Transverse Engine Mount - Abnormal Noise and Vibration on Acceleration

Service Category Drivetrain

Section Manual Transmission/Transaxle

Applicability

Figure 1.

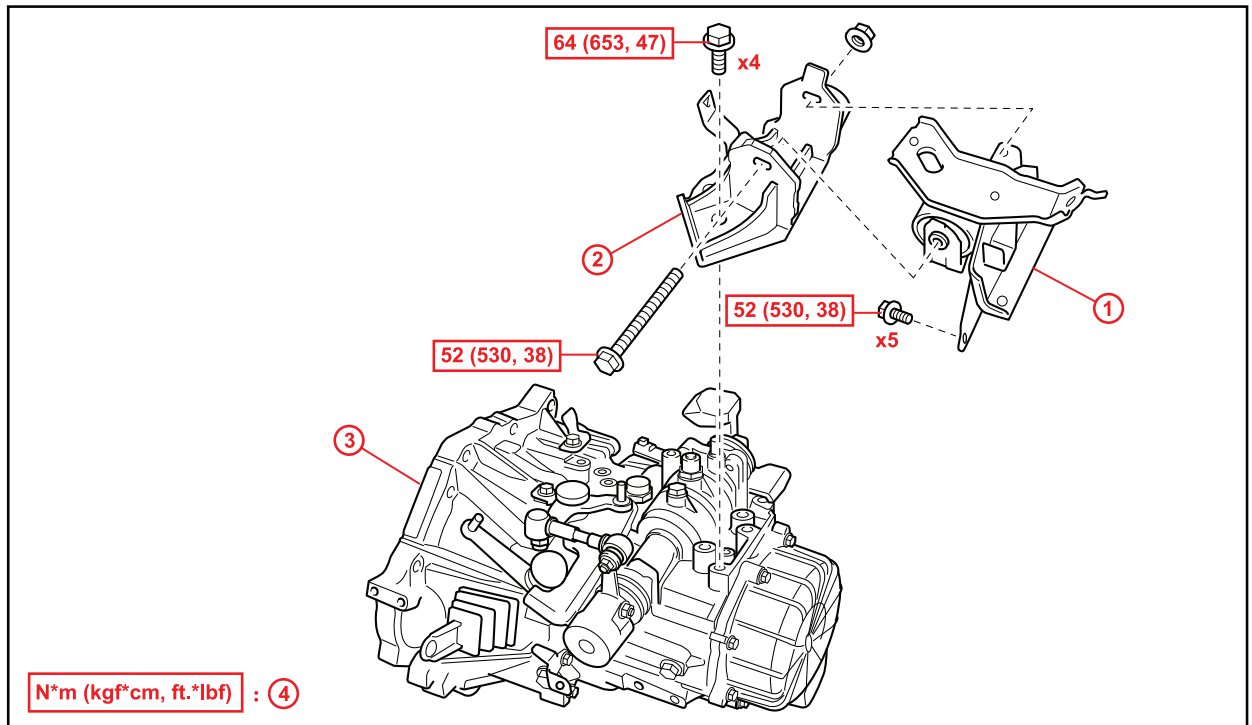
1. Confirm the customer concern.
2. Inspect the LH engine mount rubber for separation.
3. If separation is noted, replace the LH engine mount.

PREVIOUS PART NUMBER	CURRENT PART NUMBER	PART NAME	QTY
12372-21130	12372-21131	Insulator, Engine Mounting, LH	1
